June 16, 2006

URGENT SAFETY NOTICE

- Survivair Panther Twenty Twenty Plus® CBRN Facepiece nozzle found on 2420XX series facepieces.
- Survivair Panther Twenty Twenty Plus® CBRN Facepiece Air Klic found on 2420XX series facepieces.
- Survivair Panther Twenty Twenty Plus® Facepiece nozzle found on 2220XX, 2320XX, 2520XX, and 2620XX series facepieces.

Figure 1

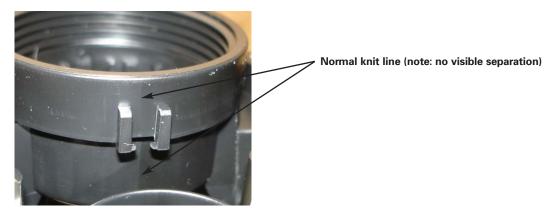
It has been determined that the SurvivairTwentyTwenty Plus® Facepiece nozzle has the potential to crack at the molding knit line if the Air Klic is over-tightened as shown in **Figure 1**. Please note that the mold knit line as shown in **Figure 2** is normal and acceptable as long as the plastic has not cracked and separated as shown in **Figure 1**. If you are uncertain as to whether there is a normal knit line or a crack in your nozzle, attempt to spread the plastic apart. If it is a crack, the plastic will separate.

Inspect your 2420XX series facepieces to see if they have a crack in the nozzle as shown in **Figure 1**. If any of the facepieces have a crack in the nozzle as shown in **Figure 1**, remove them from service and replace the nozzle with a new modified nozzle and Air Klic prior to returning the facepiece to service. If any of your 2420XX facepieces DO NOT have the modified nozzle as shown in **Figure 3**, and DO NOT have a crack in the nozzle as shown in **Figure 2**, they may be put back into service temporarily, but only until the nozzle can be replaced with a new modified nozzle and Air Klic. Contact Survivair by fax using the attached Fax Form to receive nozzle and Air Klic replacement kits.

Survivair advises all users of Panther Twenty Twenty Plus® Facepieces, series number 2220XX, 2320XX, 2520XX, and 2620XX, that if your facepiece fails a negative pressure fit check, inspect the nozzle for a crack as shown in **Figure 1**. Survivair will replace all cracked nozzles under warranty regardless of purchase date. Contact Survivair by fax using the attached Fax Form to receive replacement nozzle kits.

It is possible that the Air Klic in your CBRN facepiece may have been over-tightened at the factory during the production process. Since it is not possible to know if your Air Klic was over-tightened, we are advising all users of CBRN facepieces to replace the nozzle and Air Klic in their facepiece with a new nozzle and Air Klic as described below and provided in kits available from Survivair.
